Application for Licence

Licence Number	L3062/2025/1
Applicant	Onslow Infracore Pty Ltd
ACN	612 668 201
File number	APP-0029154
Premises	<p>Ashburton Infrastructure Project – Port Landside and Nearshore</p> <p>Legal description – Part of Lot 555 on Deposited Plan 402556 Part of Lot 569 on Deposited Plan 71345 Part of Lot 570 on Deposited Plan 71345 TALANDJI WA 6710</p> <p>As defined by the premises map attached to the issued licence</p>
Date of report	21/11/2025 (FINAL)
Decision	Licence granted

Figure 2: Distance to sensitive receptors

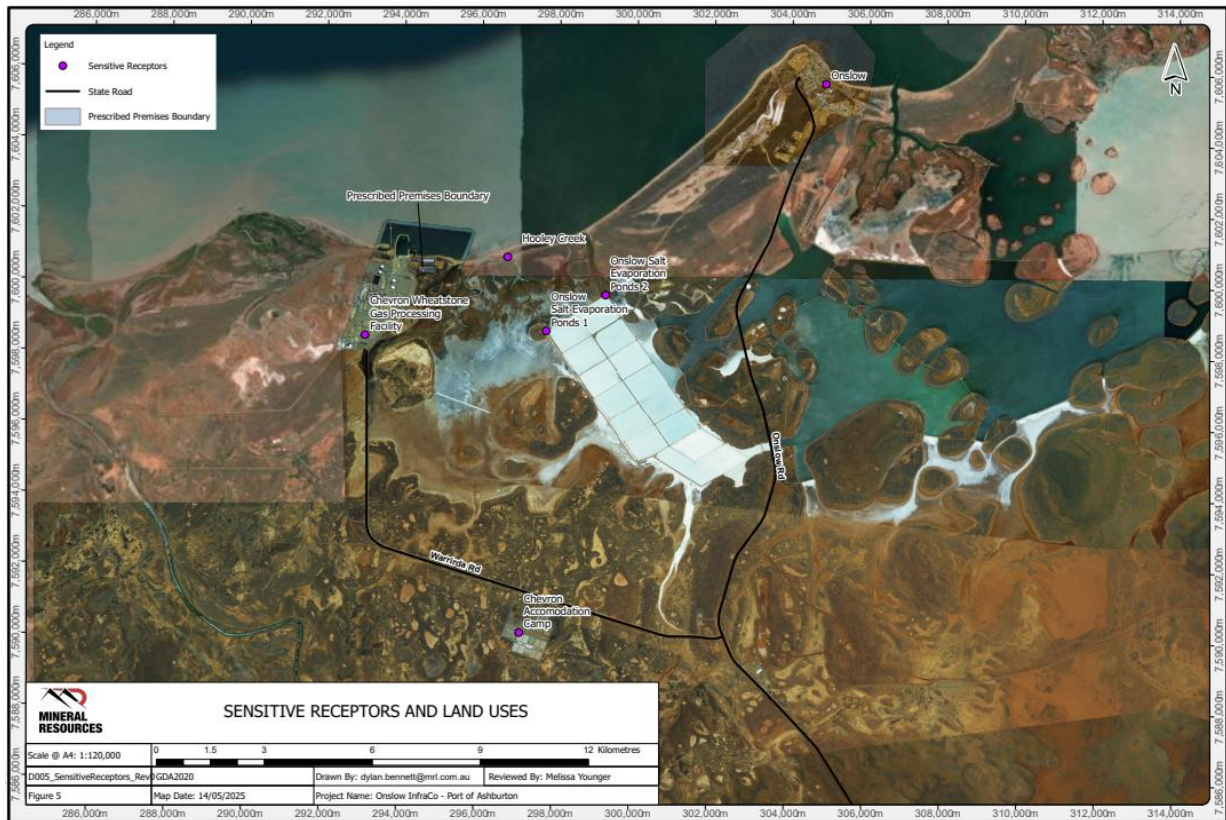
Schedule 1	<p>Applicant provided an updated Figure 2 because DWER had screened out Chevron Wheatstone Camp (including PM10 monitor) as a receptor.</p> <p>There was an oversight with one of the polygons showing locations of the excess wet solid material storage areas. A revised Figure 5 showing correct storage location was provided</p>	<p>Supported. Figures 2 and 5 updated in the licence.</p>
